# Technical Bulletin

Bulletin Number: 400 Revision Number: R-02

**SUBJECT:** 588/489 NARROW COLUMN CAN STOP SHIM

**MODELS AFFECTED:** All DNCB 588 and 489 Venders

431,010,09x.x3  
588/489 CAN STOP SHIM

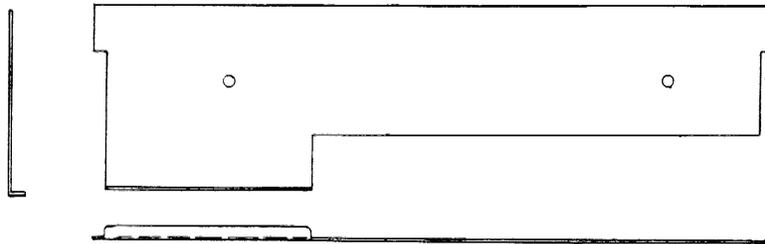
**REASON:** To provide a shim that prevents the second and/or third can from standing up and jamming.

1. Remove the existing can stop shim (431,010,05x.x3) from the narrow column. The 431,010,05x.x3 can stop shim was factory installed in venders serialized 0001-3156DN to 0001-3203DO.
2. Place the new can stop shim (431,010,09x.x3) on the right side of each narrow column.
3. The new shim allows more clearance for the cans to drop.

**ORDER:** 431,010,09x.x3 588/489 Can Stop Shim
